TOLEDO - LUCAS COUNTY PLAN COMMISSIONS

REF: SUP25-0006

SUBJECT: Request for a Special Use Permit for a Gas Station at 1565 Alexis Road

SUP25-0006

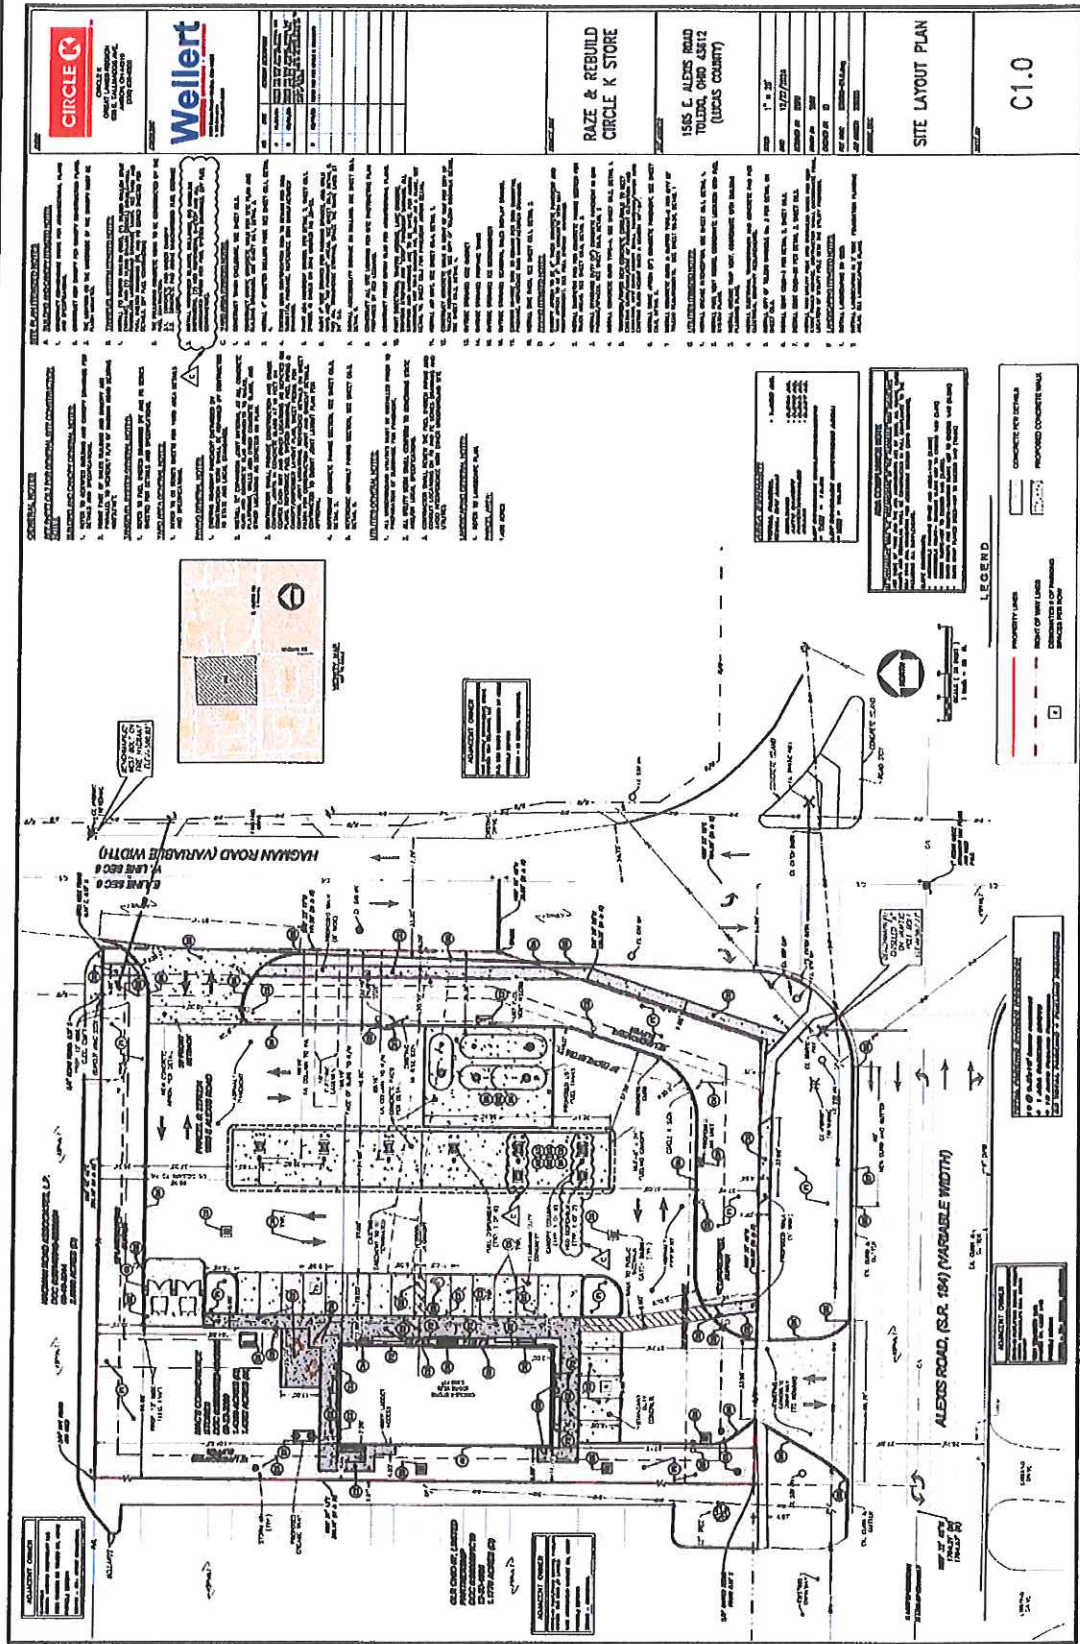
- a. The site plan meets the required minimum parking spaces (20 of 14 required), plus the 12 parking spaces at the pumps.
- b. Bicycle parking spaces are missing on the site plan. Per TMC§1107.0304, one space per 10 parking spaces shall be provided. This equates to four bicycle parking spaces. The Division of Transportation also set this condition.

- c. Per TMC §1109.0204(A) – Connecting Walkways, a pedestrian walkway from the right-of-way to the primary entrance is required. The walkway shown on the site plan goes from Alexis Road the principal building which faces Hagman Road. Given the site's configuration, an alternative cannot be determined without significant changes to the site plan.

ELEVATIONS

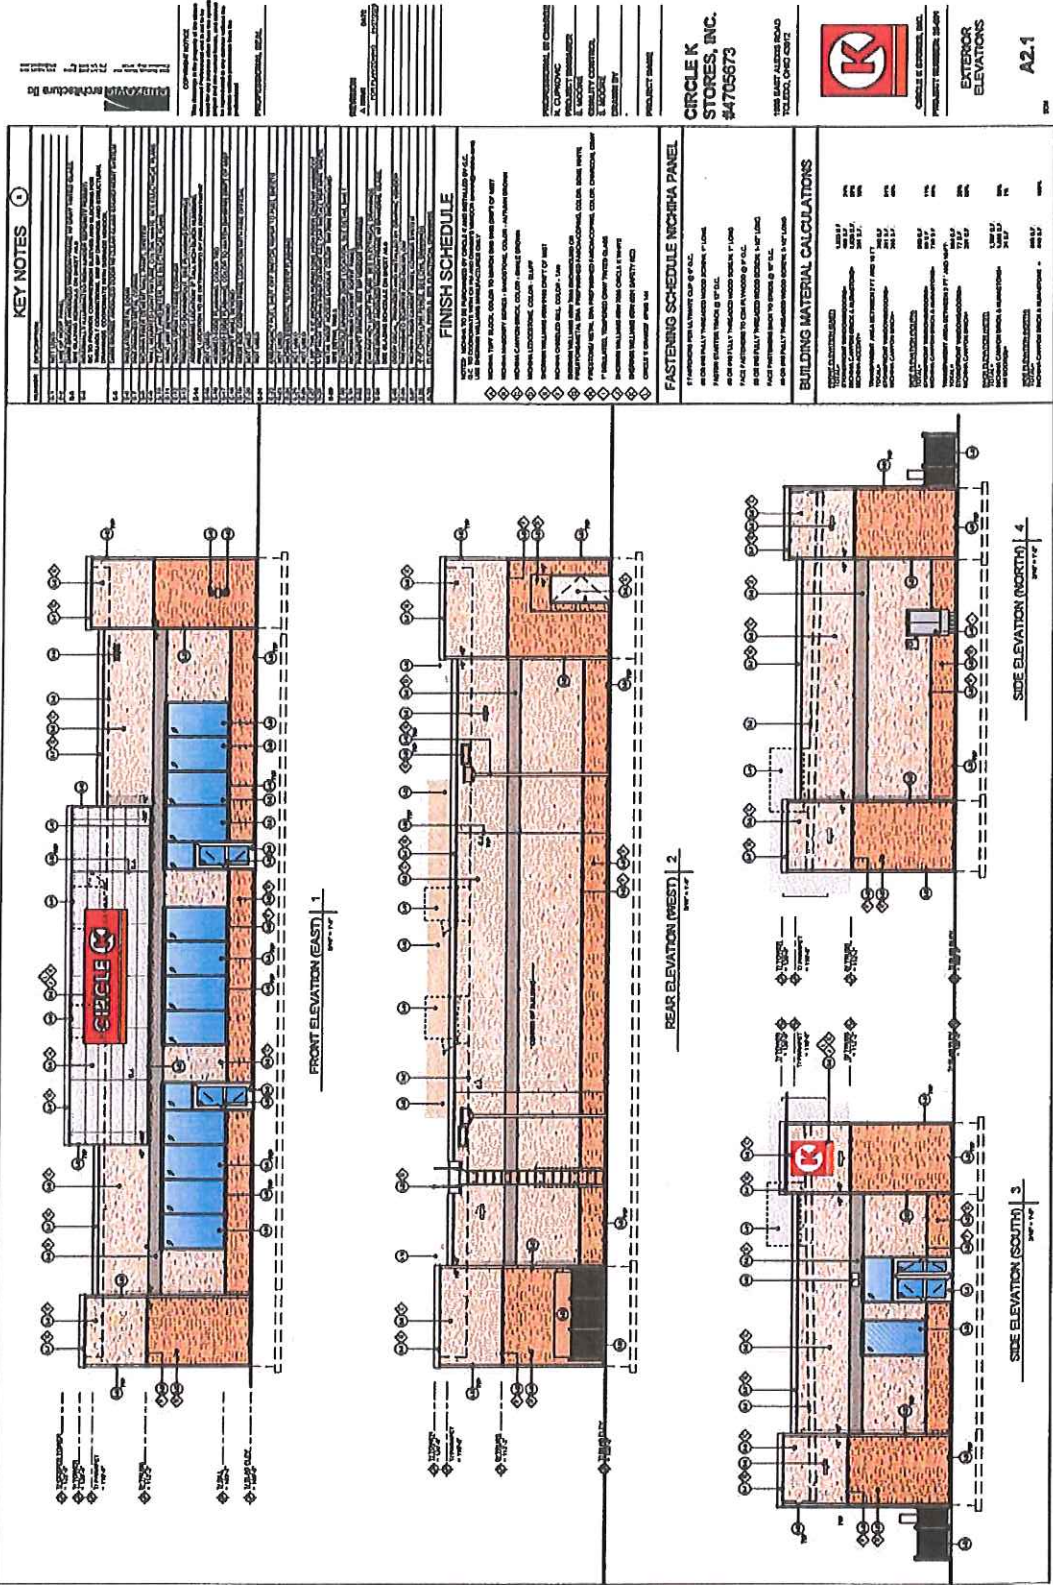
- a. The primary entrances face Hagman Road. On the East Elevation, the windows exceed the required forty percent (40%) of the elevation at grade. The South Elevation, which faces Alexis Road, does not meet the required twenty percent (20%) transparent window coverage. The window left of the doorway shown on the South Elevation is made of opaque spandrel glass.

- b. The building materials shown in the elevation are not acceptable, as the elevations depict Nichiha as the predominant façade material. This is not permitted beyond twenty (20) percent. The window coverage is not acceptable as stated above.
